HISTORIC AND DESIGN REVIEW COMMISSION

July 05, 2017

HDRC CASE NO: 2017-310
ADDRESS: 114 E HOUSTON ST
LEGAL DESCRIPTION: NCB 133 ALL OF BLK
ZONING: D, H HS, RIO-3
CITY COUNCIL DIST.: 1
DISTRICT: Main/Military Plaza Historic District
APPLICANT: Patrick Winn/TADA
OWNER: Weston Urban Brian Carney/
TYPE OF WORK: Front Patio Railing and New Ramps
REQUEST:

A2.2

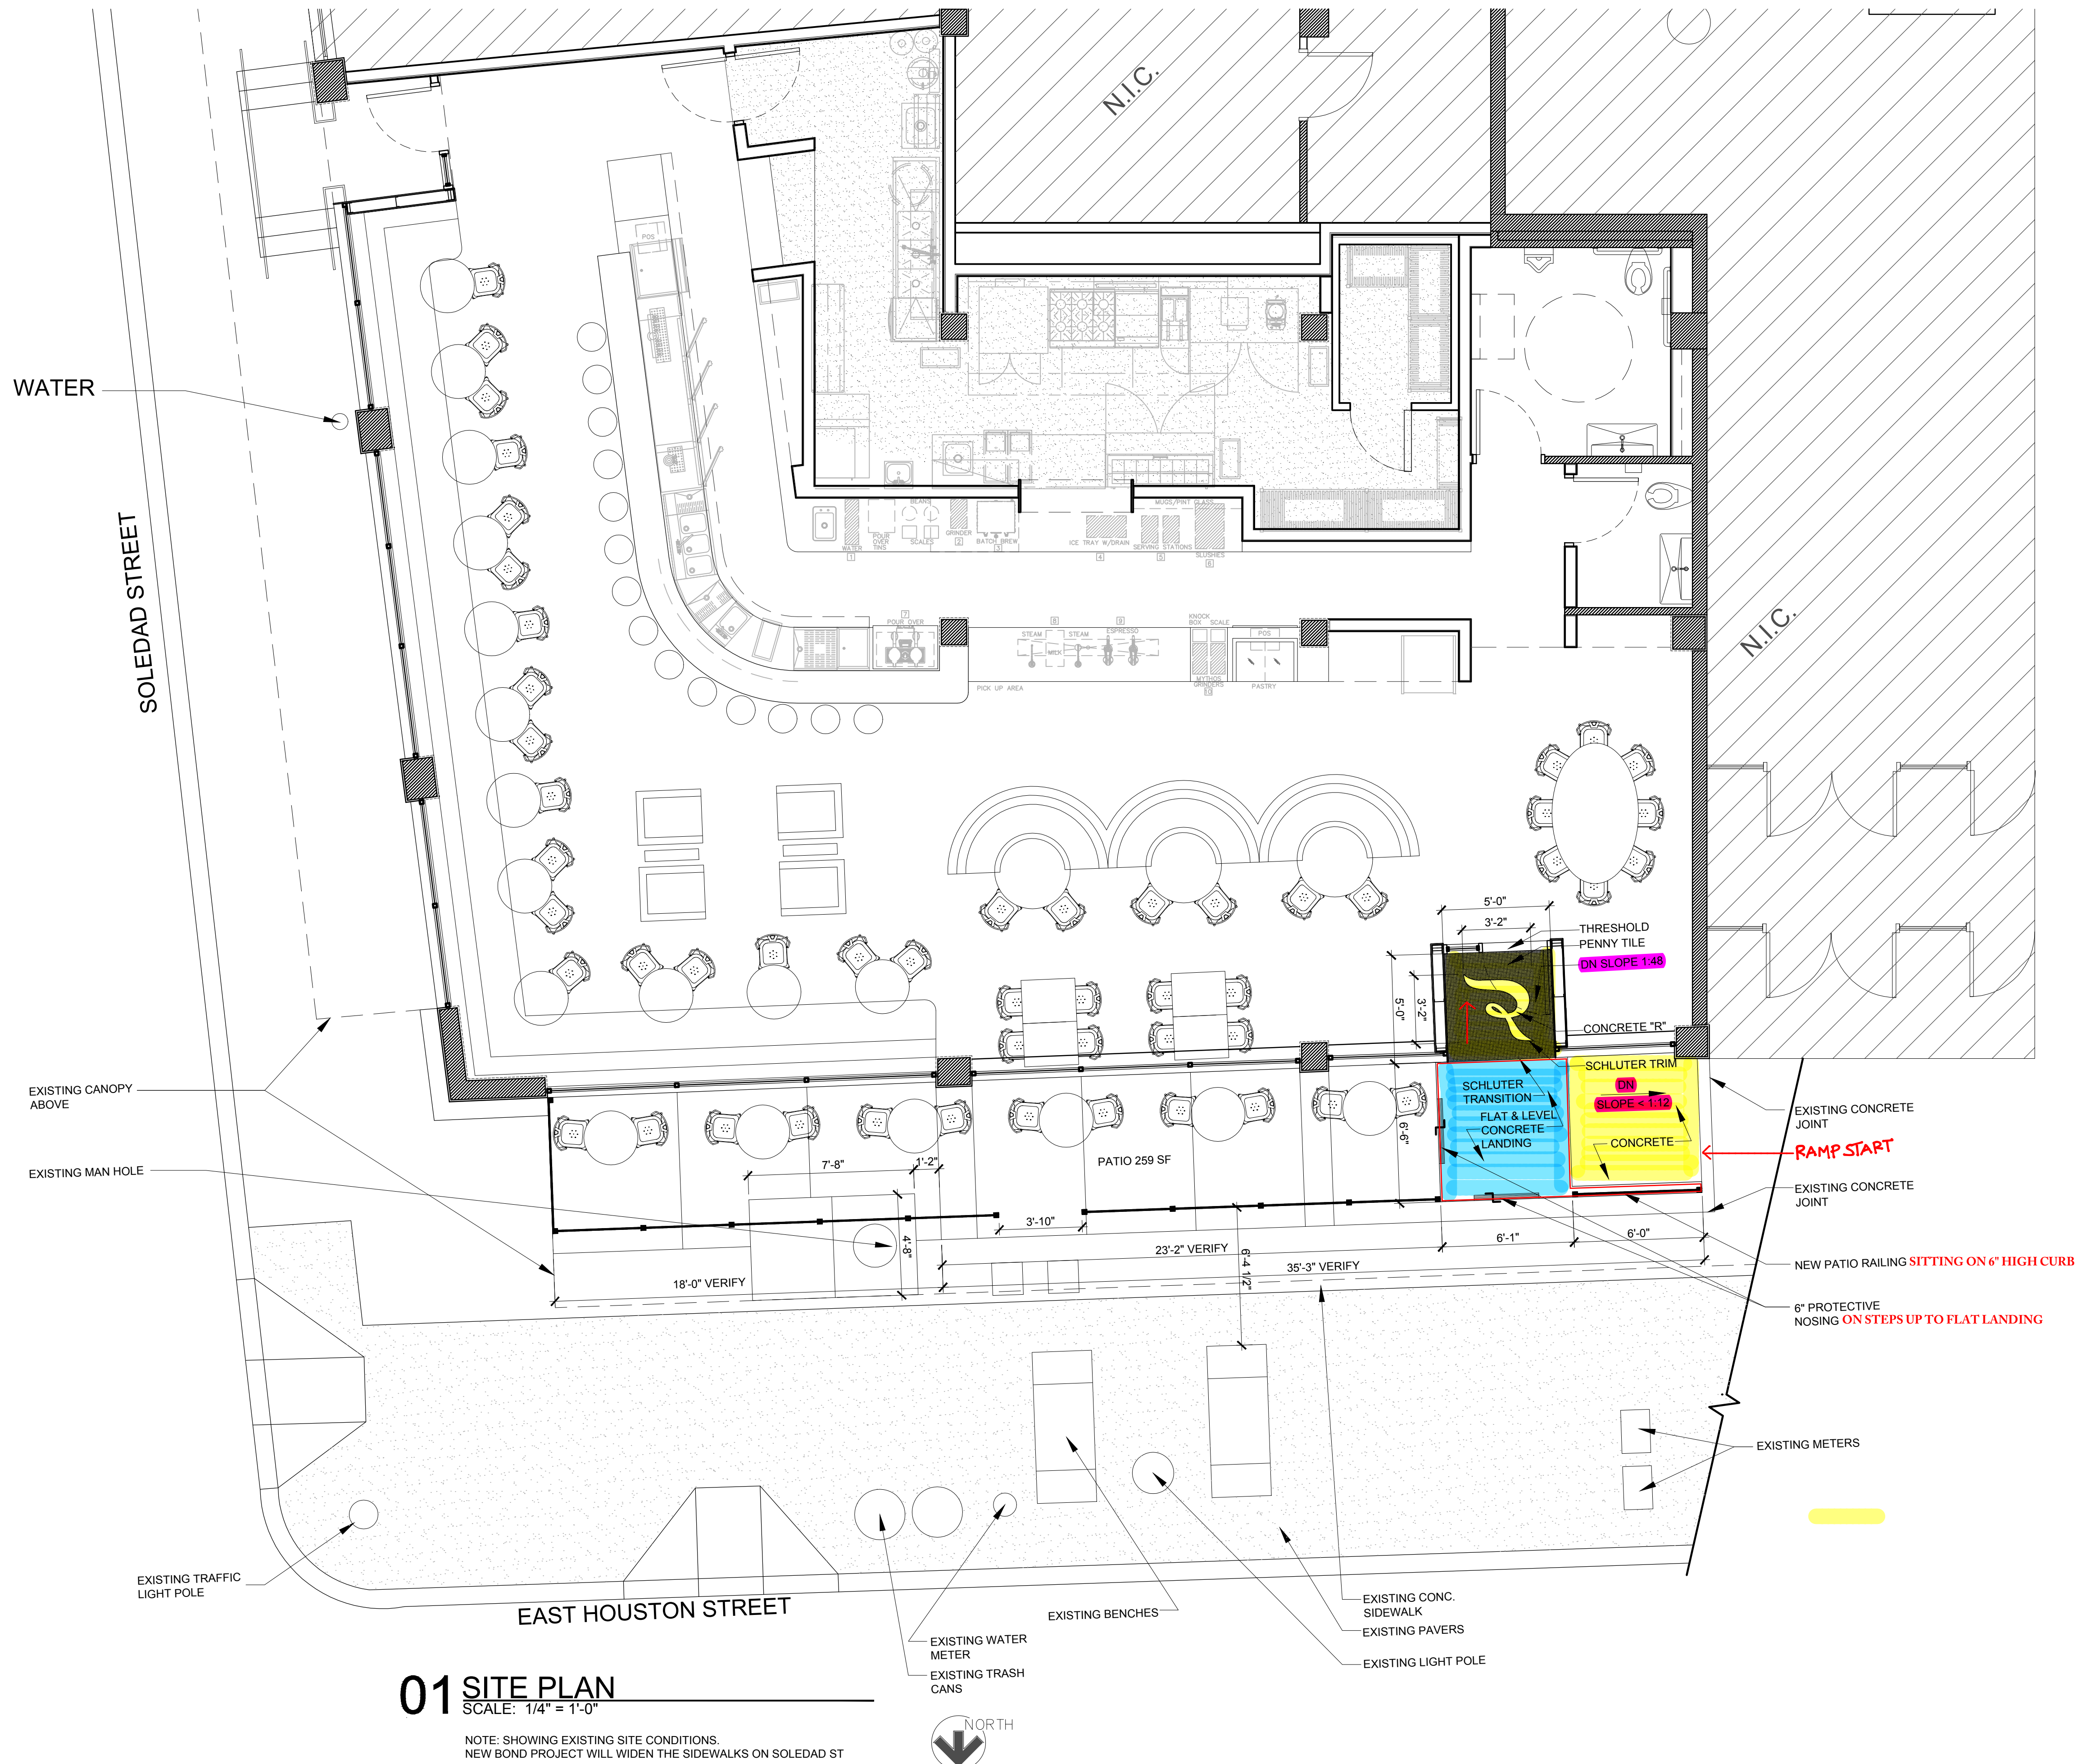
- b. OUTDOOR SEATING – The applicant has proposed outdoor patio seating on the E Houston Street sidewalk of the structure at 114 E Houston. The proposed enclosed patio area will span approximately fifty-five (55) feet long the sidewalk and will feature seven (7) feet in depth. The applicant has proposed for the patio area to be enclosed by black, wrought iron fencing featuring three (3) feet in height. The applicant has noted the installation of black steel bistro chairs and tables consisting of marble table tops and black steel bases. Staff finds the proposed outdoor seating location, fencing materials and height and patio furniture to be appropriate and consistent with the Guidelines for Site Elements.

- c. RAMP – The applicant has proposed to install a ramp featuring a slope of less than 1:12 to facilitate ADA access into a proposed entry in the third column bay on the E Houston façade. The proposed ramp will feature concrete and will feature a landing that is minimal in height immediately in front of the proposed new door opening.

Staff recommends approval based on the findings.

01 HOUSTON ST. ENTRY DOOR

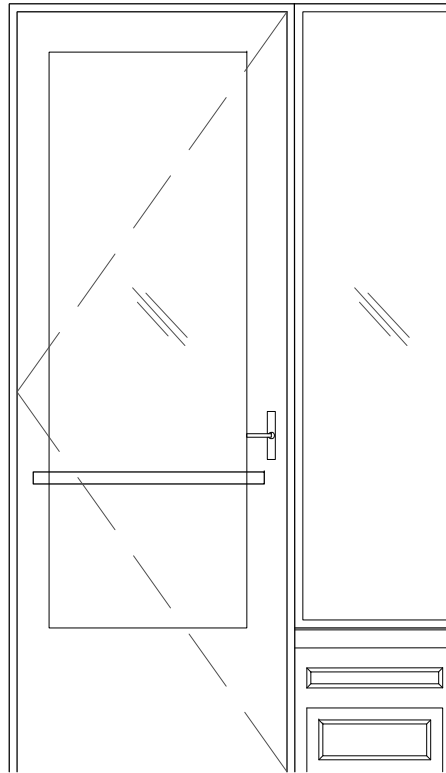
- d. FAÇADE MODIFICATION – The applicant has proposed to modify the existing E Houston Street, street level façade through the installation of a recessed entry. Per the Guidelines for Exterior Maintenance and Alterations, 10.B.i. new features or façade elements that alter or destroy the historic building character should not be installed. The proposed entry vestibule will be located entirely within a middle window bay. The proposed materials consist of wood which are found in the current storefront system. Staff finds that this installation is appropriate and will not greatly disrupt the existing building fabric.
